## **CENTRAL BAPTIST SUBDIVISION**

APPLICATION NUMBER 6 DATE June 16, 2005

APPLICANT Central Baptist Subdivision

REQUEST Subdivision

# CENTRAL BAPTIST SUBDIVISION

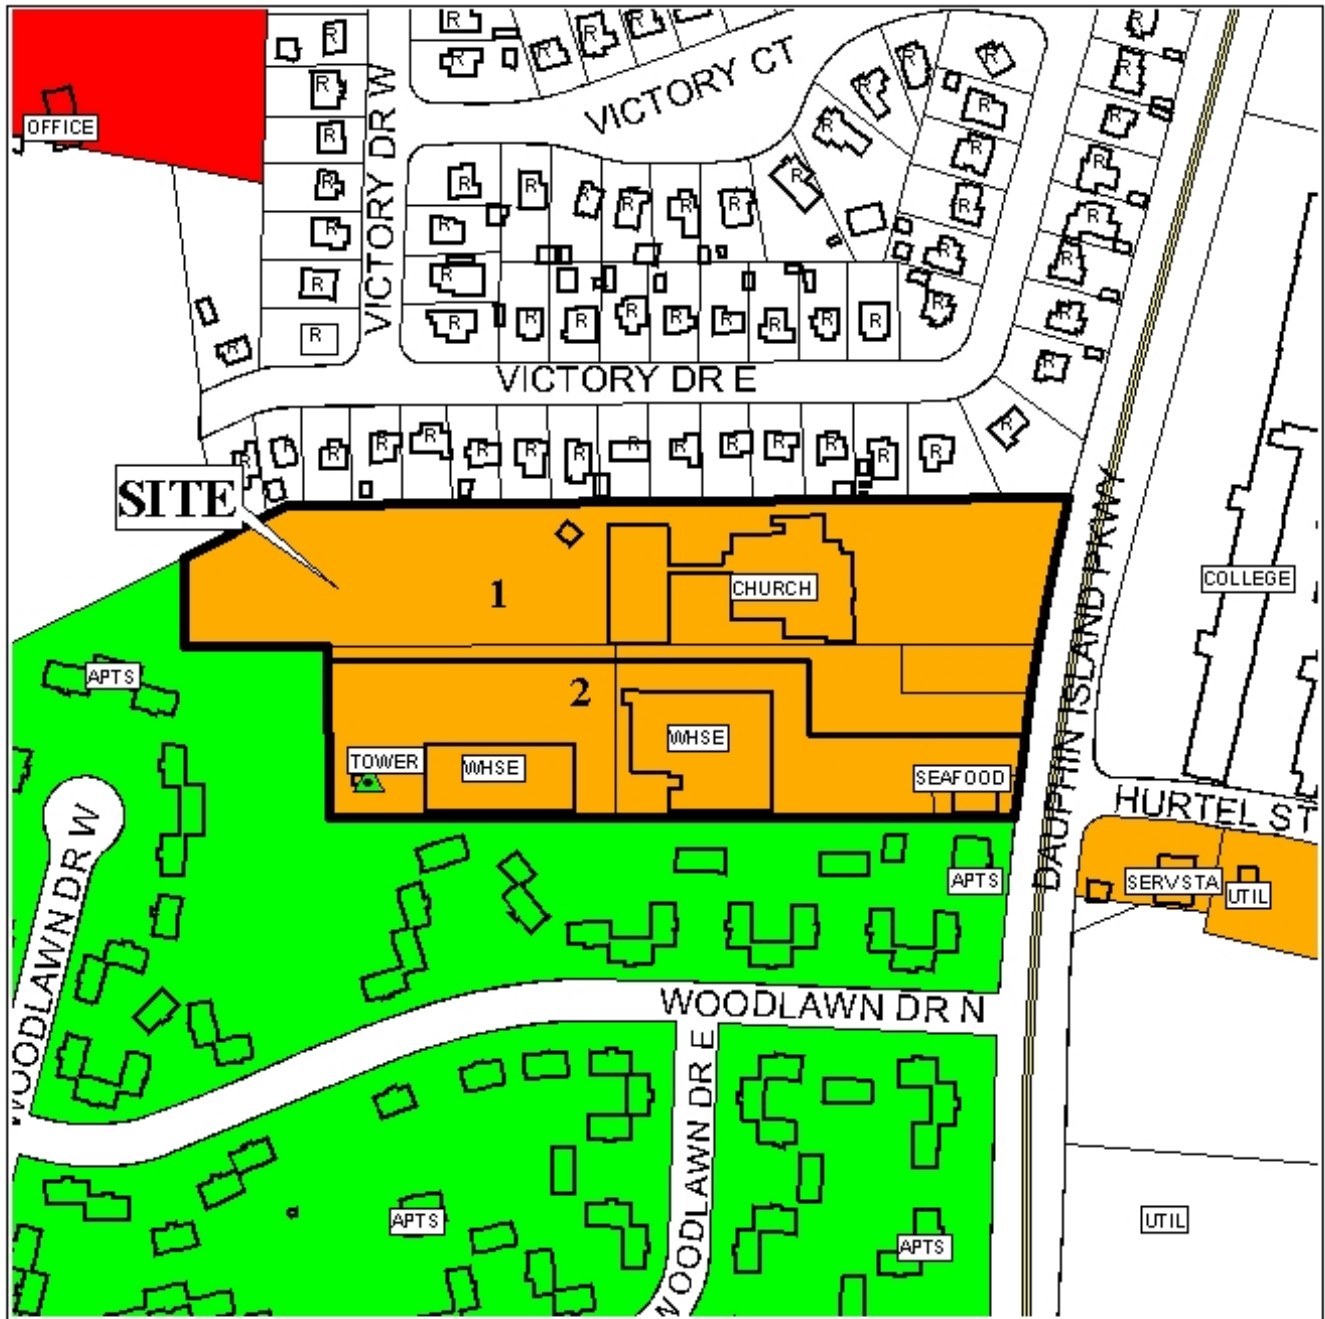
Dauphin Island Parkway is a proposed major street, and as such should have a right-of-way width of 100 feet, according to the Major Street Plan. The Alabama Department of Transportation (ALDOT) states that the existing right-of-way in this area ranges from 85 to 90 feet wide, which conflicts with the width depicted on the preliminary plat. It is therefore recommended that the applicant confirm the right-of-way width with ALDOT, and if found to be less than 100 feet, dedicate an amount sufficient to provide a right-of-way width of 50 feet as measured from the centerline of Dauphin Island Parkway.

Access management is a concern along Dauphin Island Parkway because of its status as a major street. As previously mentioned, the site currently shares access via two curb-cuts onto Dauphin Island Parkway. It is recommended that the shared-use of curb-cuts be continued, with no additional curb-cuts provided. Should the existing curb-cuts need modification, or if new curb-cuts are proposed, the number, design, location and size of all curb-cuts must be approved by Traffic Engineering and ALDOT, and conform to AASHTO standards.

The 25-foot minimum building setback line is not depicted on the plat, but would be required on the final plat, if approved.

The proposed depth to width ratios for the two lots exceed the 3.5 depth to width ratio recommended in Section V.D.3. of the Subdivision Regulations; Lot 1's ratio is 3.65, while Lot 2's is approximately 8.25, due to the flag-shaped nature of the lot. Existing development adjacent to the north, south and west precludes other subdivision options, therefore a waiver of Section V.D.3 could be considered appropriate.

With a waiver of Section V.D.3., the plat is recommended for Tentative Approval, subject to the following conditions: 1) completion of an administrative PUD; 2) depiction of the 25-foot minimum building setback line; 2) placement of a note on the Final Plat stating that the lots will continue to share existing curb-cuts, and that any new or revised curb-cuts must be approved by Traffic Engineering and ALDOT, and conform to AASHTO standards; 3) placement of a note on the Final Plat stating that subdivision of the site to more than two lots is not permitted unless a public street is provided; and 4) if necessary, dedication of right-of-way sufficient to provide 50-feet of right-of-way width from the centerline of Dauphin Island Parkway.
